Karooni Fashions Ltd.

5 October 2021

Observation: KFL Building

Column layout

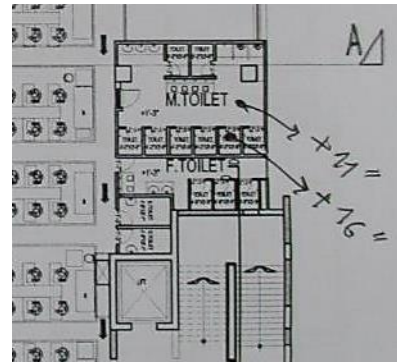
Column stresses above normal design limit

Cursory calculation indicate that column stress exceeds the normal design limit considering minimum concrete strength (16.3 MPa) and prepared floor live load plan (3 kPa on typical floors and 6 kPa on storage areas). The building engineer is required to verify the in-situ concrete strength, review the column stress.

Toilet Block

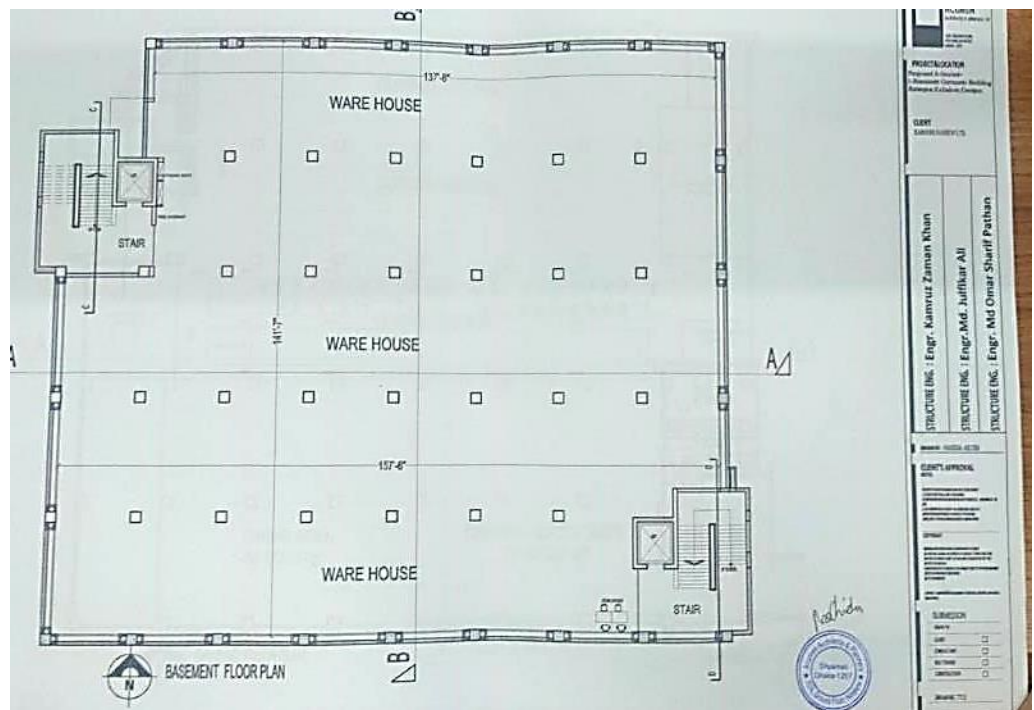
Additional imposed 400 mm floor built up

6 kPa loading on 7th floor

TEST REPORT

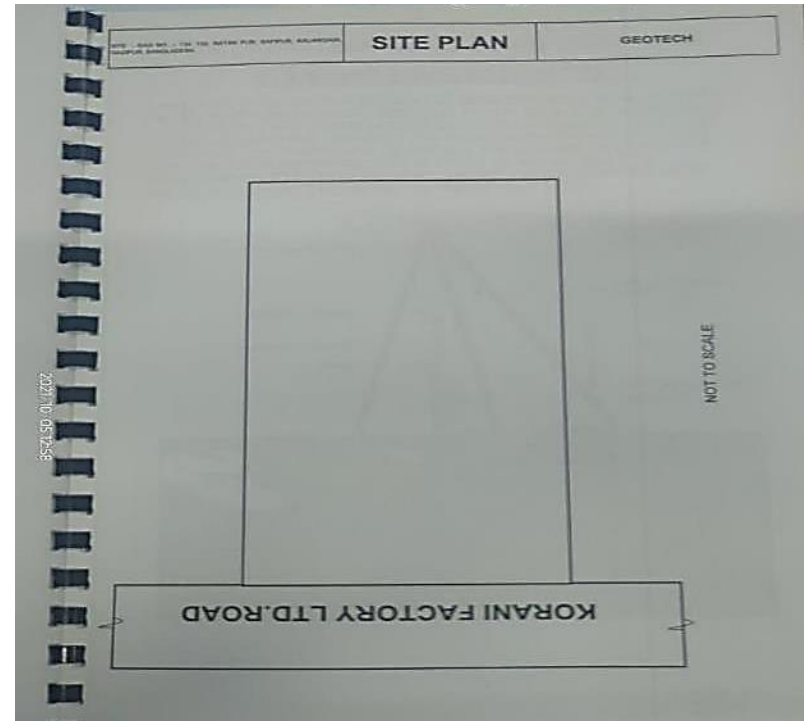
Inconsistency in material test report (soil and concrete)

Location of the building & bore hole locations are missing in the soil test report.

Conduct geotechnical investigation to close vicinity of the structure, determine actual soil bearing capacity and check the foundation adequacy. Maintain proper records of testing [Soil & concrete].

OHWT on the roof

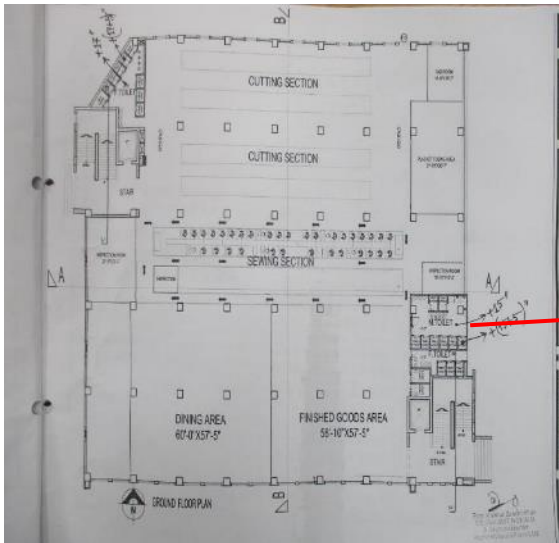
Retaining wall on the basement floor

RC parapet on the roof

Structural details of OHWT & parapet wall on the roof and retaining wall on the basement floor are not shown in the structural drawings. The building engineer is required to survey the structural components and produce accurate structural details.

Floor layout plan (floor rise 375 mm all floor)

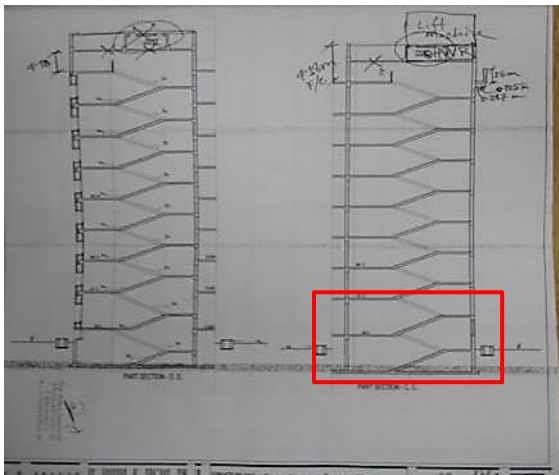
Approx. 450 mm floor rise on ground to 3rd floor and 200 mm on other floors

Floor rise, floor height, brick wall layout does not match with as-built conditions. The building engineer is required to survey the structure and produce accurate as-built drawings.

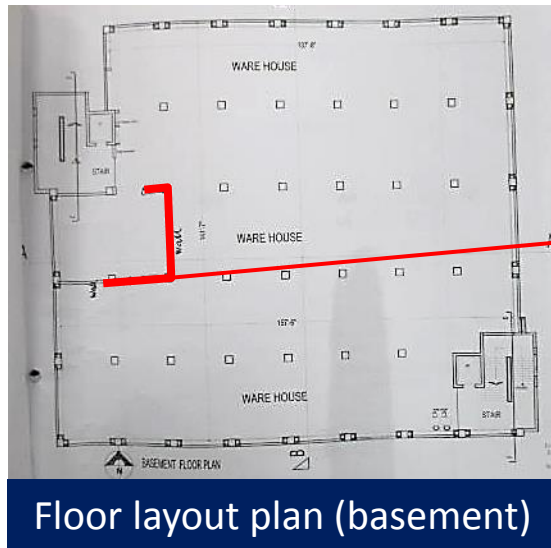
13'-8" floor height at basement & GF instead of 14'

Floor layout plan (basement)

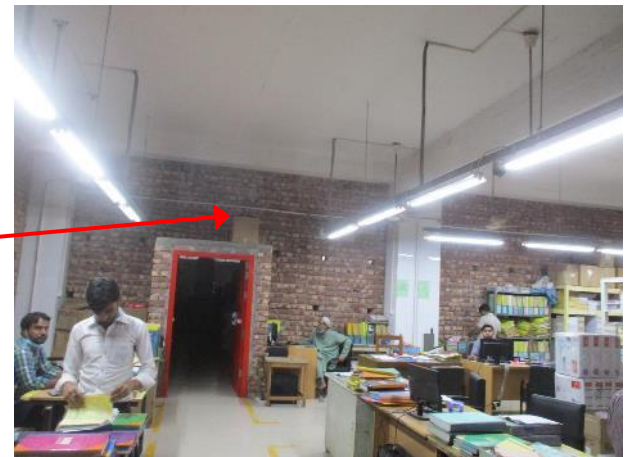
Brick walls on basement floor not shown in drawing

5th floor plan (production)

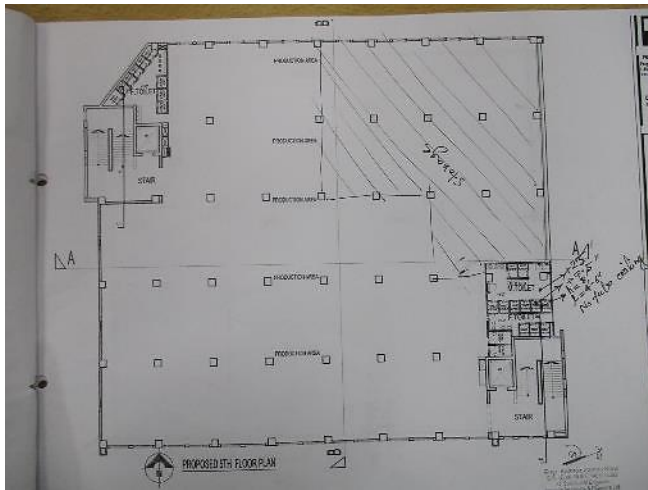
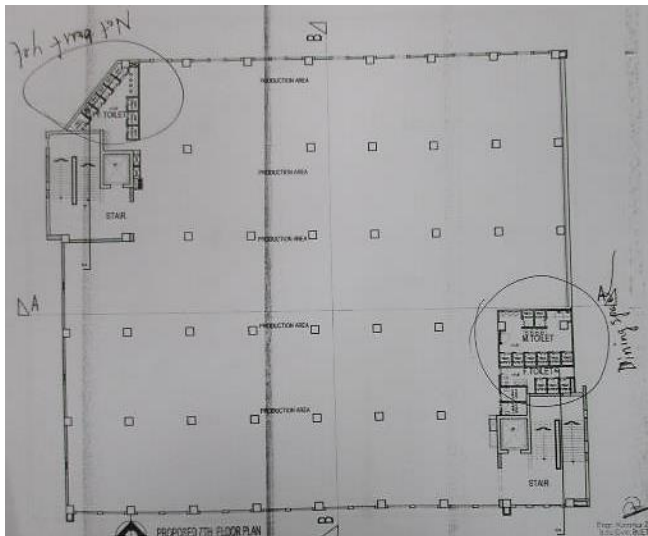
Storage on the 5th floor

On the 5th and 7th floor storage was observed on production area. The building engineer is required to check the occupancies and update the floor live loading plan for all floors based on BNBC requirements and manage the floor loading accordingly.

Free standing parapet wall

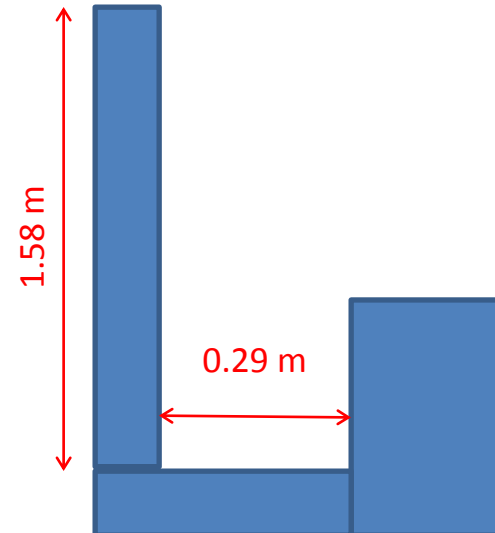
Roof parapet wall missing on the eastern side

Free standing wall observed on the beam bottom cantilever slab.

The RC parapet wall is resting on the beam bottom cantilever slab. The factory is required to provide parapet wall to the eastern part of the roof. The building engineer is required to check the lateral stability of the parapet walls and check the capacity of below cantilever slabs.
